-Tutorial-
What is the correct
terminology
for the media path?

P802.3by Interim Meeting
Milpitas, CA

This is about disapprove comments that I put in regarding the use of the term "channel" on D2.0 and D2.1.

Figure 112-3—Fiber optic cabling model

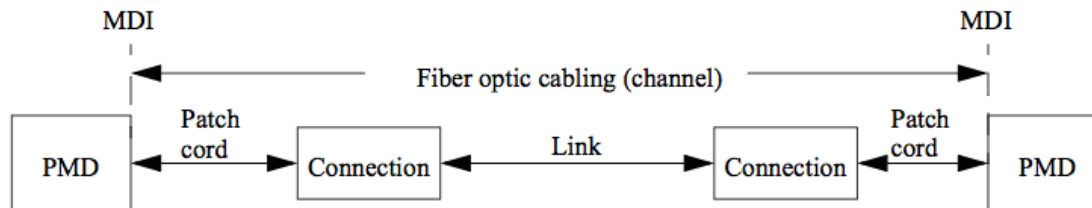
My comment on D2.0 was rejected on the basis that:
"Consistent with the previously listed clauses, 112.9 says "the term channel is used here for consistency with generic cabling standards". NOT TRUE

"Changing a previously used term for a single clause might be confusing."

PERPETUATING ERRORS IS POOR PRACTICE

CONSISTENCY WITH REMOTE LOCAL LABELS OVER
GLOBAL LABELS IS JUST WRONG.

- 1) Where you mean the MDI-to-MDI connection use:
"link segment"
(See: 112.9, 112.10 for 2 of several examples)
